Proposal from the Dual-Axis Dynamometer Task Force

This is the agreed text proposal that was developed by the Dual-Axis Dynamometer Taskforce. The taskforce's request to the WLTP-IWG is to adopt this proposal at the 21st meeting of the IWG on 9 January 2018, and to add this text to the informal document on Amendment 4 of GTR 15.

“Figure A6/2

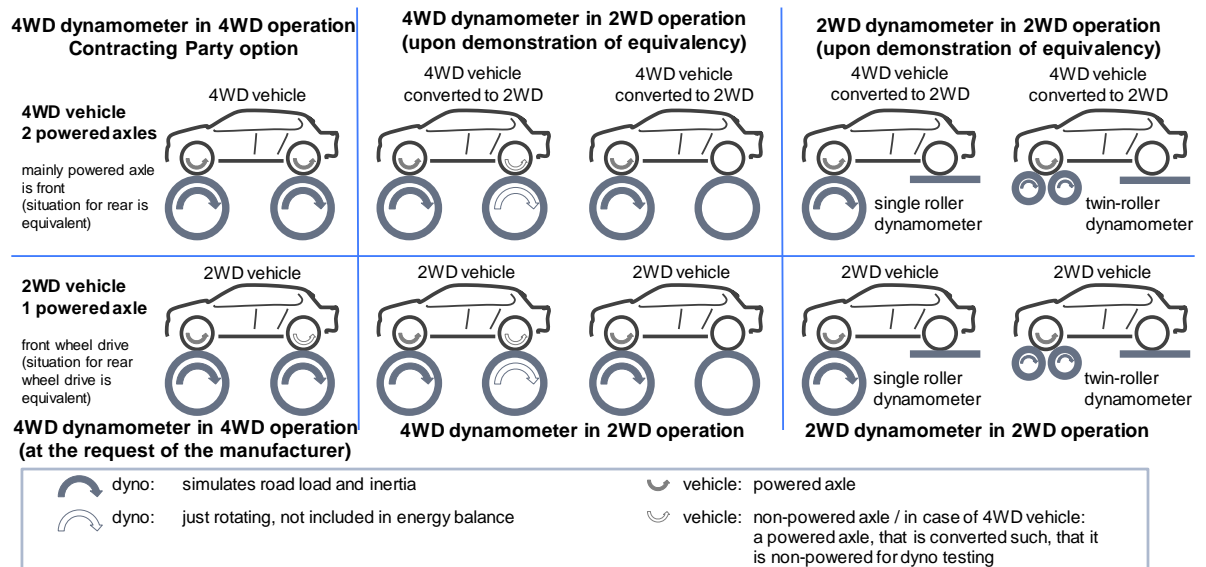
Add graph to paragraph 2.4.2.4:

Possible test configurations on 2WD and 4WD dynamometers

- “2.4.2.4. If the test vehicle has two powered axles, and under WLTP conditions is partially or permanently operated with two axles being powered or recuperating energy over the applicable cycle, the Contracting Party may require the vehicle to be tested on a dynamometer in 4WD operation which fulfils the specifications in paragraphs 2.2. and 2.3. of Annex 5.

- 2.4.2.4.1. If the test vehicle is tested with only one powered axle, the test vehicle shall be tested on a dynamometer in 2WD operation which fulfils the specifications in paragraph 2.2. of Annex 5.

At the request of the manufacturer and with the approval of the responsible authority a vehicle with one powered axle may be tested on a 4WD dynamometer in 4WD operation mode.
